Aerial of 30 Whitlock Avenue

Staff Analysis:

V2012 - 44
30 Whitlock Avenue, Starbucks

Dumpster design:

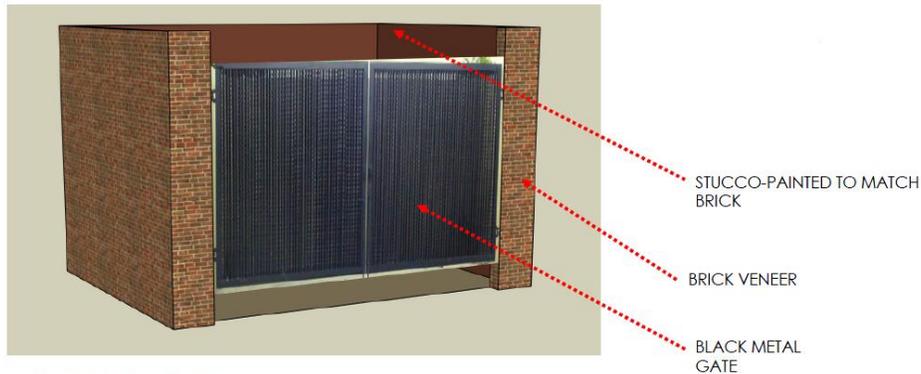
The existing dumpster enclosure is located in the far eastern corner of the property and appears to be constructed of cinder block painted white. The design of the new enclosure submitted to and approved by the HBR consists of a brick veneered enclosure with black metal gates. Because of the location of the building and drive through on the "L" shaped lot, there is no feasible location for the dumpster that would place it further from the right of way than the principal building, as required by Section 708.16 (F)(1). Not only will the higher quality building materials planned for the enclosure aid with aesthetics, the proposed placement will be in the least visibly obtrusive location of the site.

Section 708.16 (F)(1) also requires all accessory structures to be placed at least 10' from the side and rear property lines. Although the site plan shows the structure 5' from the rear, the petitioner is asking for a variance to reduce the setback from 10' to 3' to take into consideration possible design

modifications or field error. Because the adjacent property is another parking lot, a reduction of the required setback should not adversely affect the neighboring property.

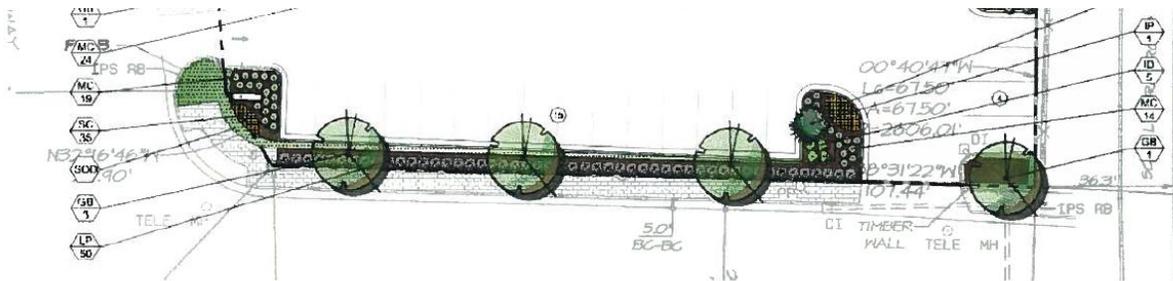
No more than 12 parking spaces in a row are allowed without a planter island. The current parking lot contains only one tree island at the southeastern corner. And, although the proposed plan shows the creation of four new tree islands, the proposed stretch of 15 spaces against Whitlock Avenue will not meet code.

The code contains an alternative design approach to providing tree islands. The tree island requirement may be waived in those instances where facing parking rows are separated by a continuous island at least five feet in width containing at least one small or medium canopy tree every twenty feet. Although this clause appears to imply that the strip must be provided between two facing rows, staff has historically taken the interpretation that the islands may be waived as

long as the parking spaces face a landscape strip at least 5' wide and containing a small or medium canopy tree every twenty feet. However, the proposed design by Starbucks will not comply with this alternative because the landscape strip does not meet the 5' width required.
